Product Change Notification

Product Group: OPT/Tuesday September 1, 2026/PCN-OPT-1495-2026-REV-0

IL41x, BRT2x, VO41xx, VO306x OptoTRIACs green production line transfer

PCN OPT-1495-2026 Package Dimensions Comparison

DIP-6

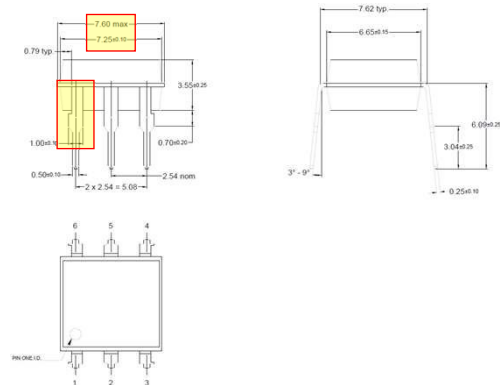
Note: major changes are the package length and the lead shape form

DIP-6, 400 mil (option 6)

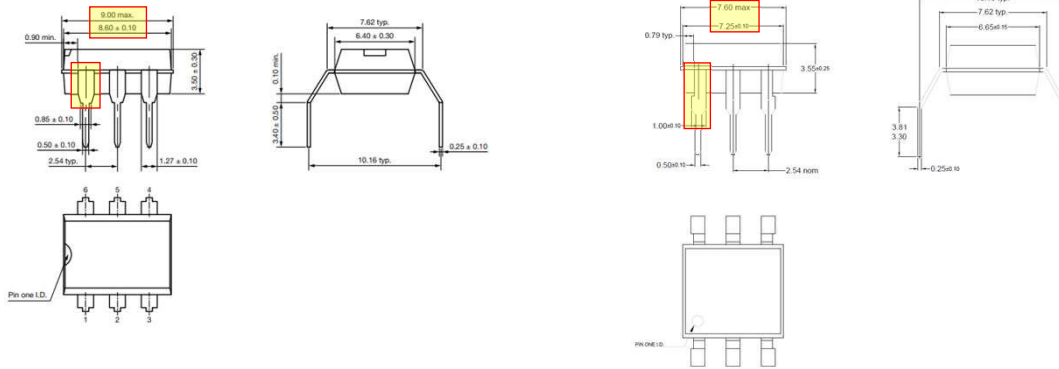
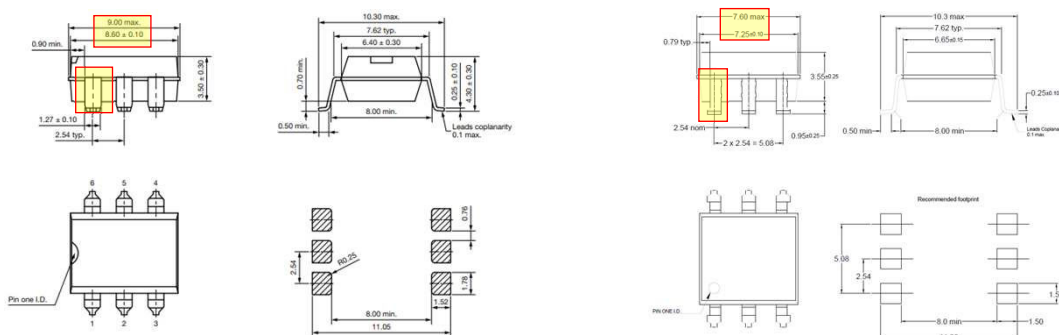
Note: major changes are the package length and the lead shape form

SMD-6 (option 7)

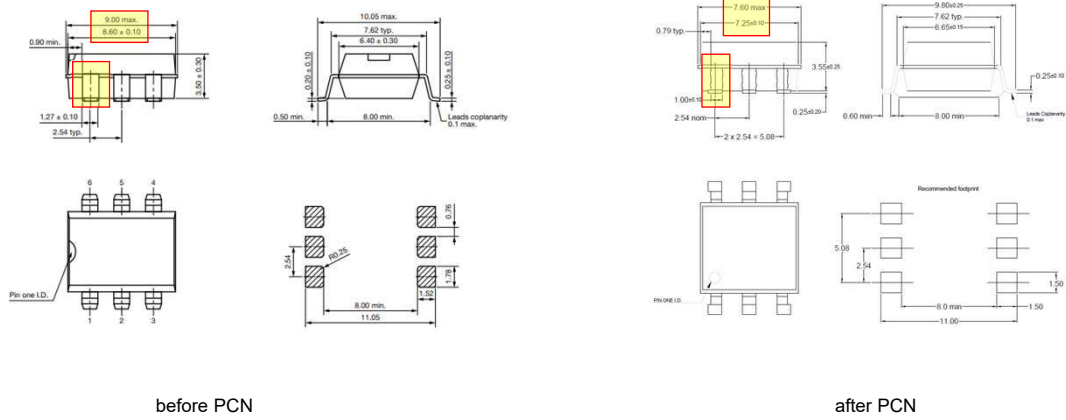
Note: major changes are the package length and the lead shape form
